Bay Networks

Part No. 116950-A Rev. A

Technical Notice

Corrections to *Installing and Operating BayStack ARN Routers*

Figure 1. Attaching Brackets to Rack-Mount the ARN

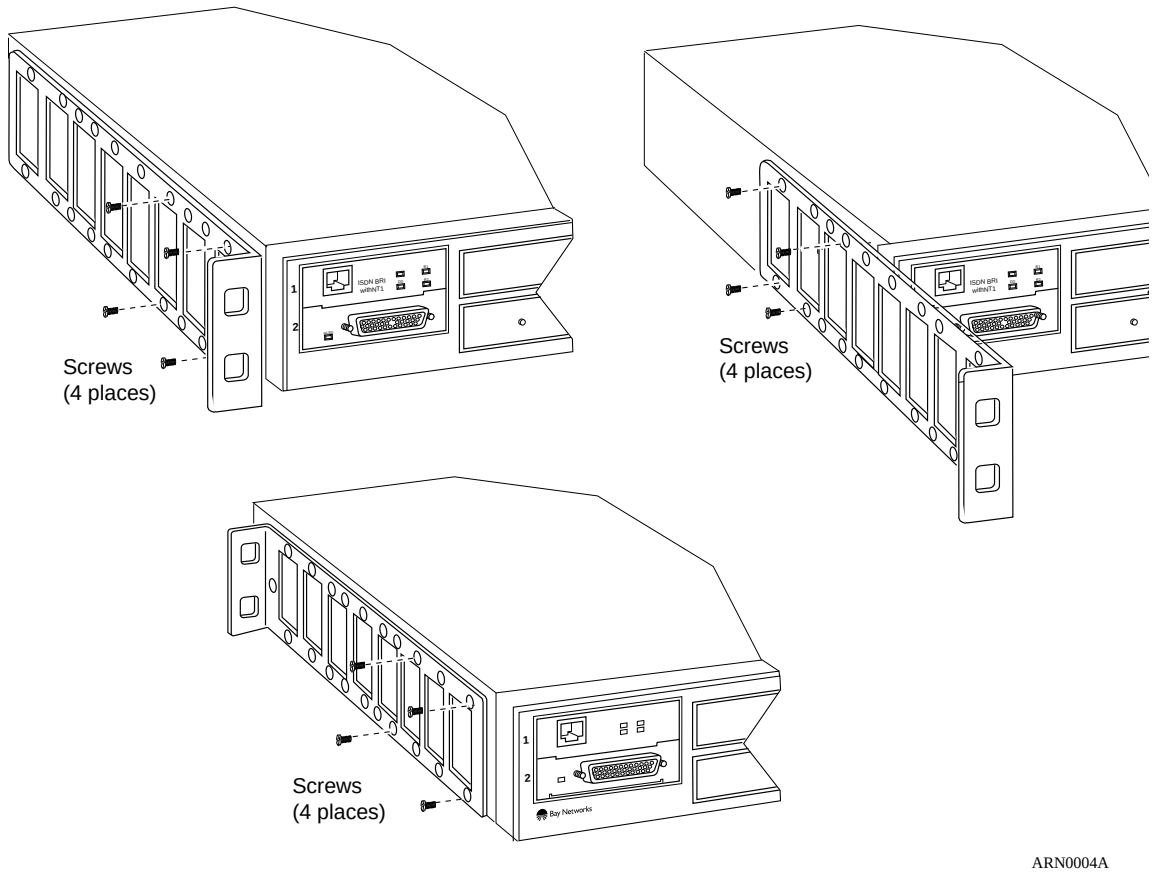
The flange brackets for mounting the ARN in a rack now support additional rack positions. Figures 1-1 and 1-2 in *Installing and Operating BayStack ARN Routers* illustrate the wrong mounting bracket. Figure 1 correctly illustrates the options for attaching the new mounting brackets.
